**METROPOLITAN GOVERNMENT OF NASHVILLE AND DAVIDSON COUNTY**

**STAFF RECOMMENDATION**  
**Ransom Avenue/Byron Close Development**  
**120 Ransom Avenue**  
**March 15, 2017**

**Application:** New construction--infill  
**District:** Elmington Place Neighborhood Conservation Zoning Overlay  
**Council District:** 25  
**Map and Parcel Numbers:** 104100001100  
**Applicant:** Barlow Builders  
**Project Lead:** Melissa Baldock, melissa.baldock@nashville.gov

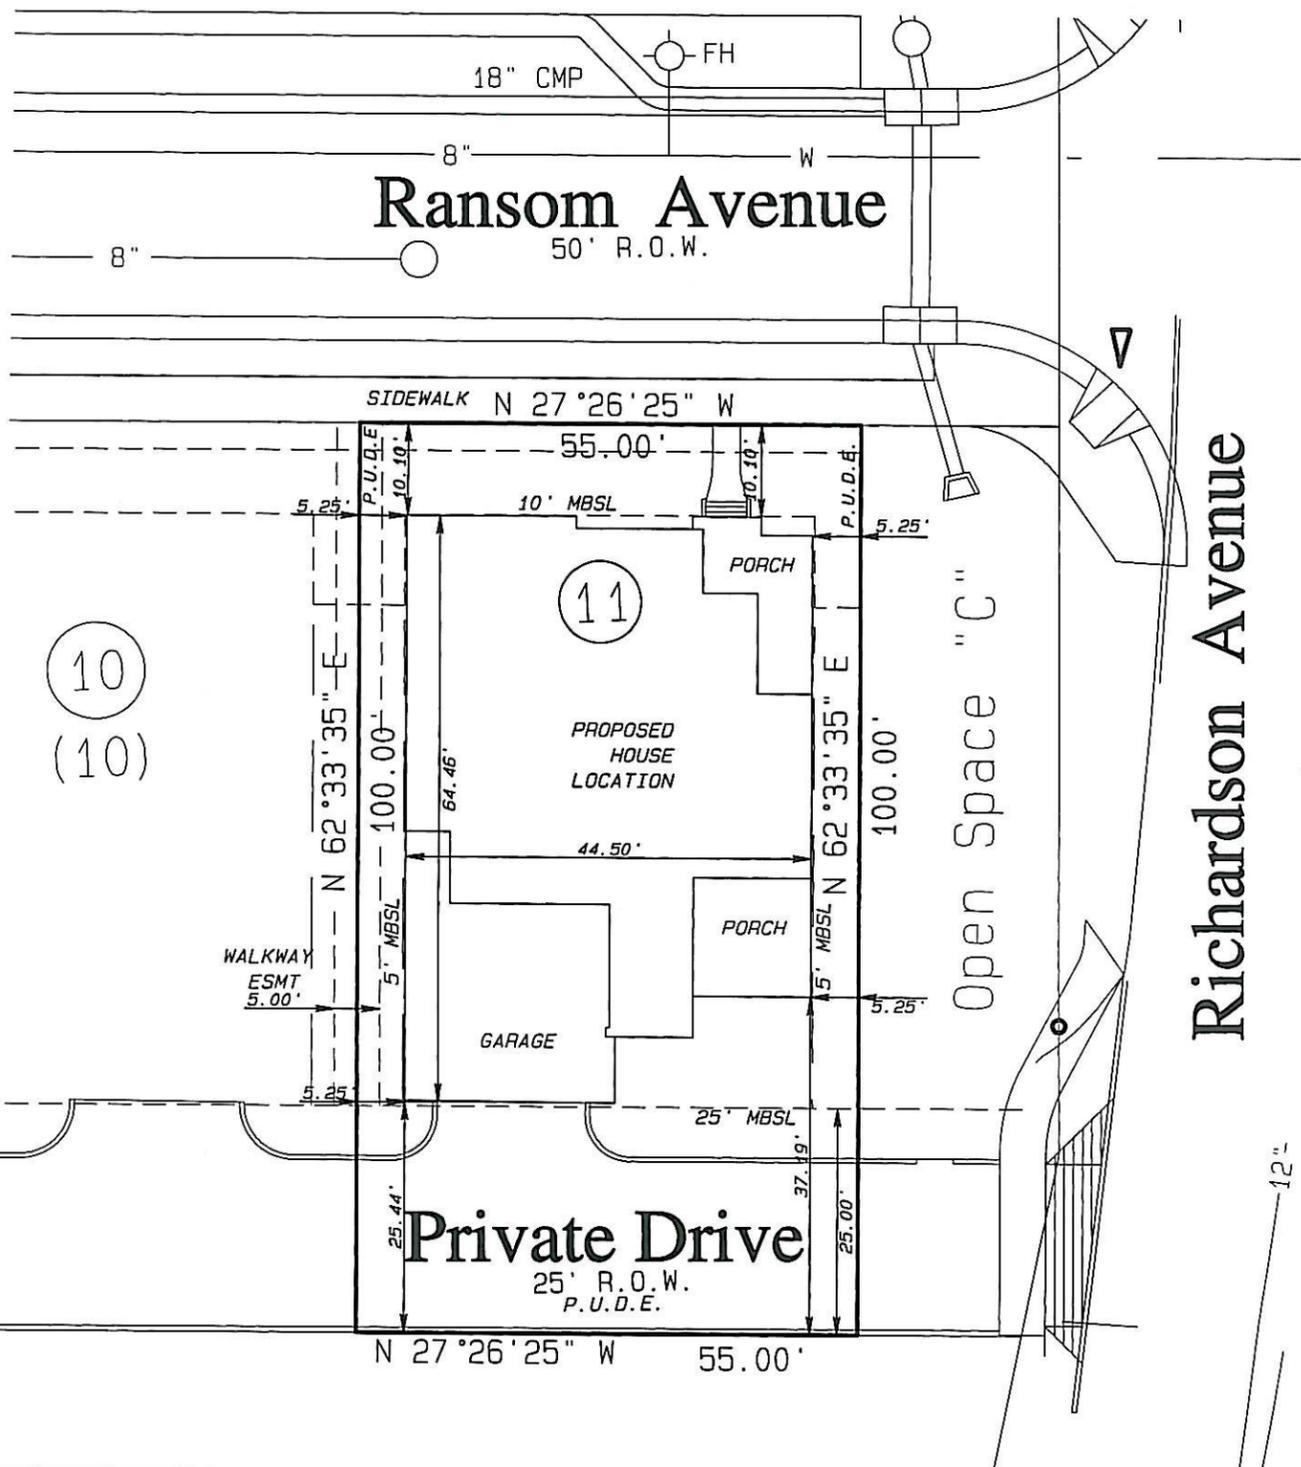
Roof form: The main roof form is a cross gable. The front and side gabled bays have slopes of 14/12, and the main side gable has an 8/12 roof form. The front porch roof is flat, and the side porch is a 2/12 hipped roof. There is a hipped two-story section of the house at the rear. Staff finds that the proposed roof forms meet the historic context and meet Section II.B.1.e. of the design guidelines.

Orientation: Lot 5 is located off of Richardson Avenue. Its left side façade will front Richardson Avenue. The house’s primary orientation is towards Ransom Avenue, but it addresses Richardson Avenue with a wrap-around porch that is six feet (6’) deep and a secondary entrance facing Richardson Avenue. In addition, the house’s roof forms and fenestration pattern on the right elevation further serve to provide secondary orientation towards Richardson Avenue.

Proportion and Rhythm of Openings: The window proportions on the proposed infill are approximately twice as tall as they are wide, matching the historic context. All double

and triple window openings have four to six inch (4-6”) mullions in between them, which is appropriate.

\* Staff recommends that the side porch columns have a cap and a base.

**FIRST FLOOR PLAN**  
SCALE: 1/8" = 1'-0"

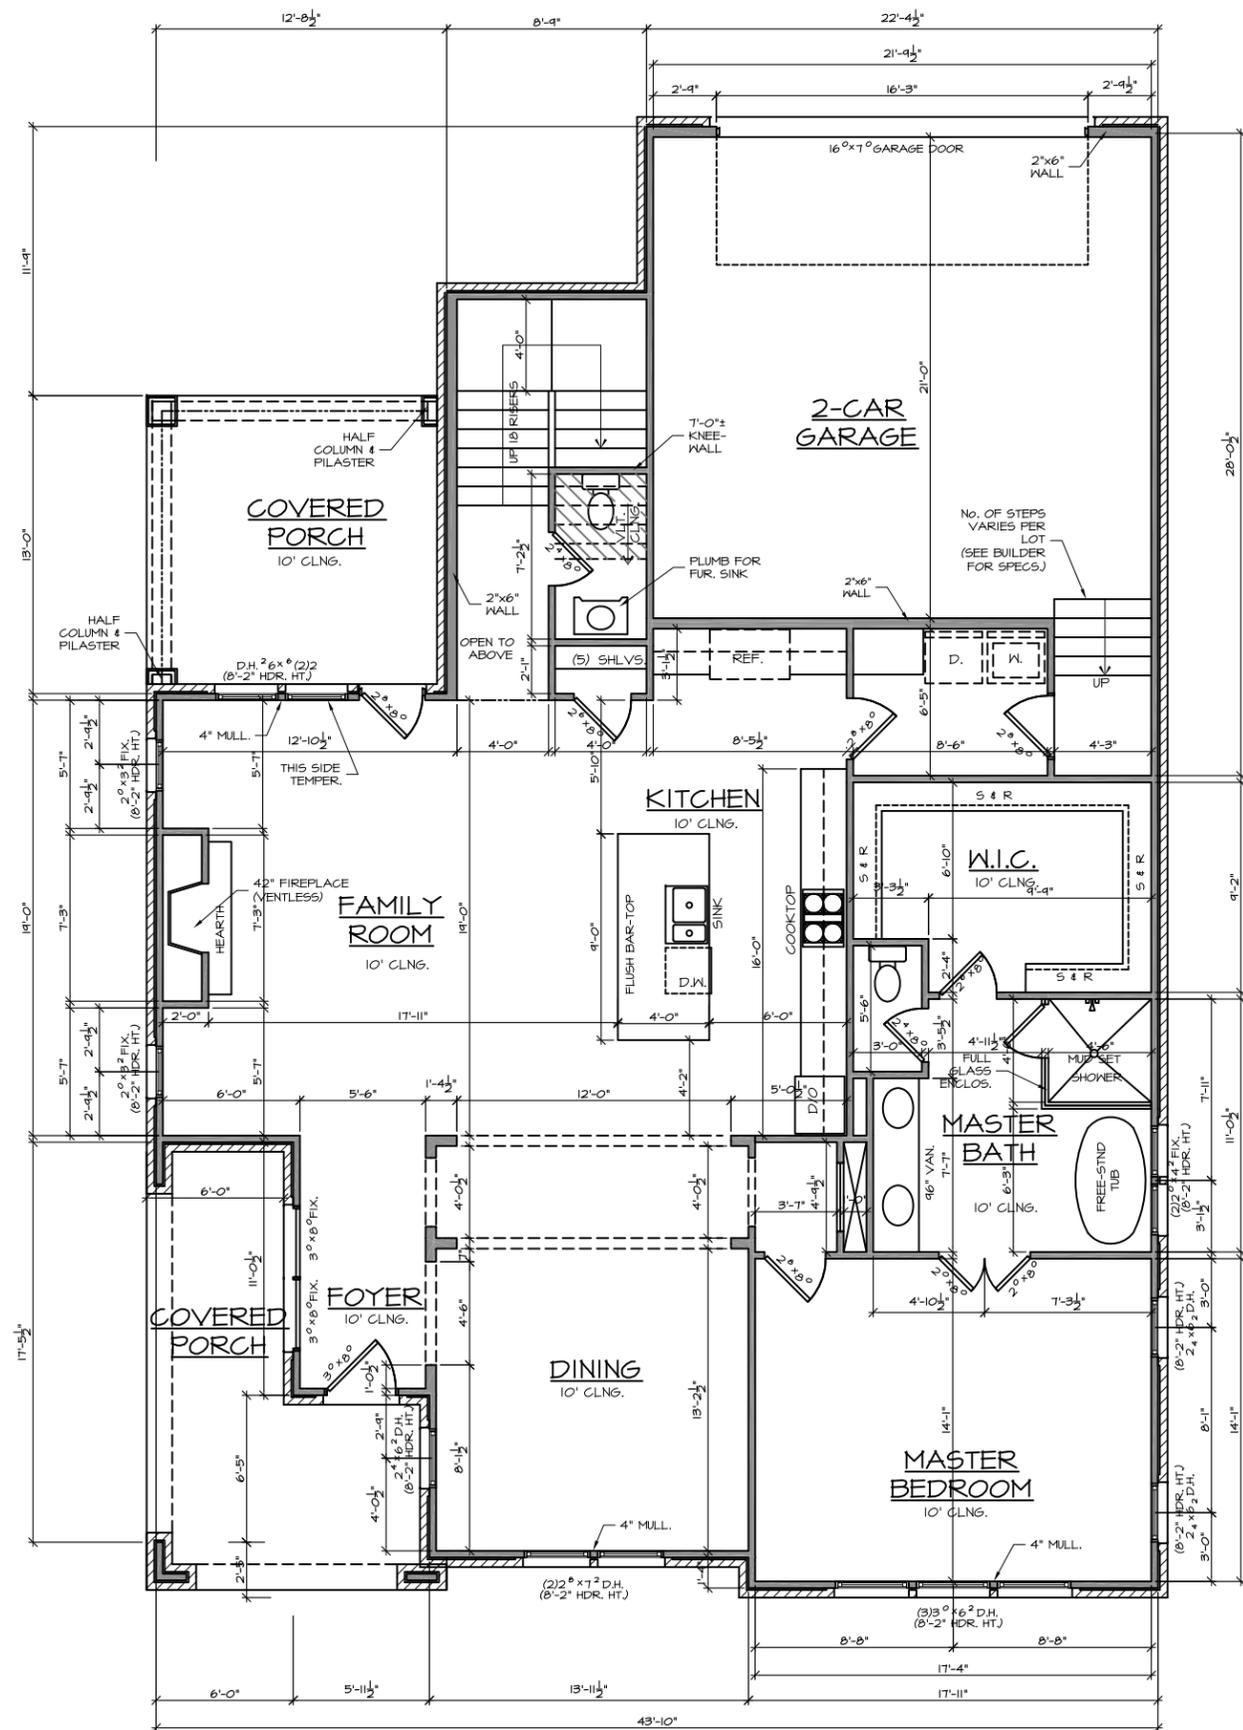
The right side façade has a wall expanse larger than fifteen feet (15’) without a window or door opening. This expanse is located behind the back half of the façade, and it does not front either Richardson or Byron Avenues. Staff finds them to be appropriate because the houses are just ten feet (10’) apart from each other, and the wall space will be at most minimally visible from the street. Staff finds that the infill’s proportion and rhythm of openings meet Section II.B.1.g. of the design guidelines.

Appurtenances & Utilities: The location of the HVAC and other utilities was not noted. Staff asks that the HVAC be located on the rear façade, or on a side façade beyond the midpoint of the house.
